**Wangsgard Property**  
 PART OF THE SE 1/4 OF SECTION 18, T.6N., R. 2E., S.L.B. & M., U.S. SURVEY  
 HUNTSVILLE, WEBER COUNTY, UTAH

**Site Sketch Plan**

**Wangsgard Property**  
 Huntsville City, Weber County, Utah

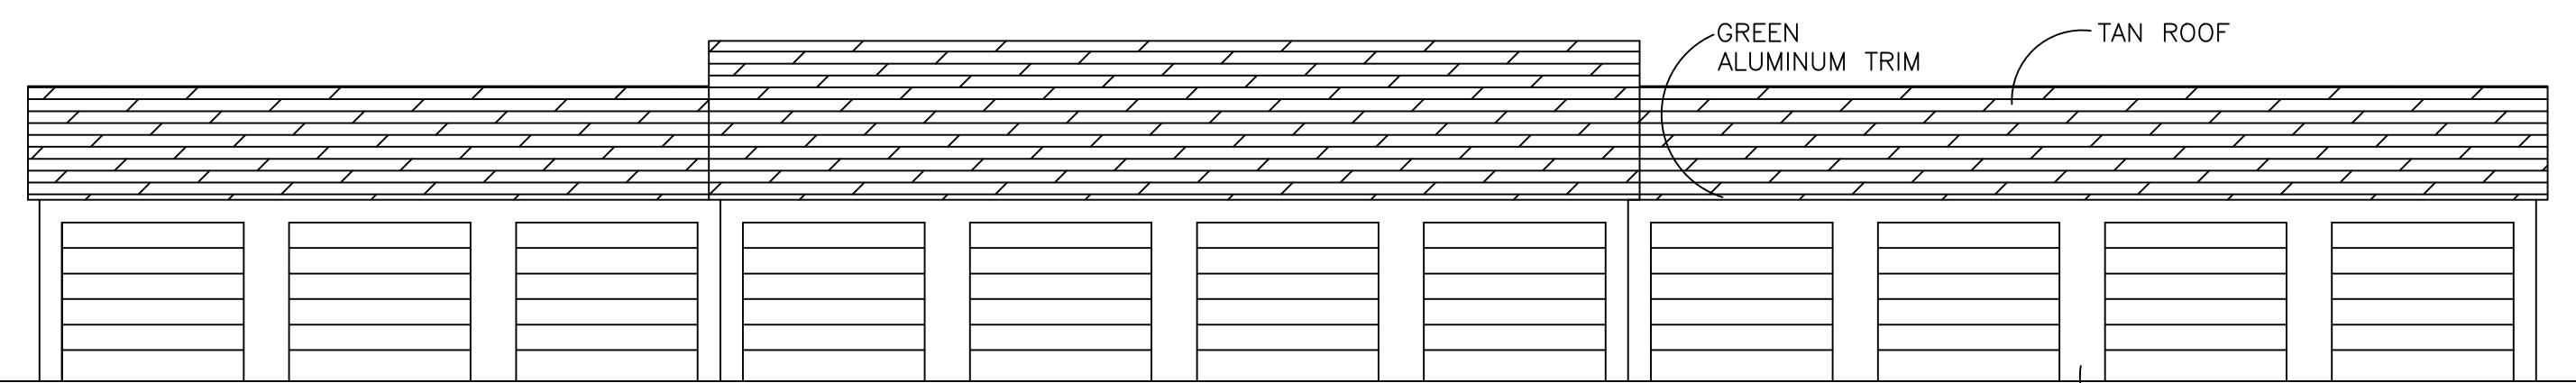
Please provide a summary data table indicating the area of the site in the following classifications:  
 a. Total area of the site:  
 b. Total area and percentage of the site in landscape area:  
 c. Total area and percentage of the site in turf grass.

Please specify what these improvements are. There appears to be existing hard surface around 'Existing BLDG 1' and 'Existing BLDG 2'. Will that same surface be installed in front of the 'Proposed buildings'?

Will the driveway be the same surface?

Chainlink fencing is not allowed for screening and buffering as stated in LUC 108-2-7. Please remove. I suggest extending the vinyl fence. Please include color (must be muted earth tone and non-reflective finish).

Turf grass can make up a maximum of 50 percent of the total landscaped area. Please provide additional plant material to make up the other 50 percent. Please provide the location, quantity, size and name (both botanical and common names) of all proposed plant material.

Please include an irrigation plan indicating the locations and types of all equipment, including sprinkler heads, control valves, quick-coupling valves, backflow prevention devices, time clock of controller, lateral lines, and main lines.

Please include the location and dimensions of all existing and proposed structures, property lines, easements, parking lots and drives.

Is there enough room for multiple customers to park and load/unload at a time? Please explain or show how traffic congestion will be mitigated.
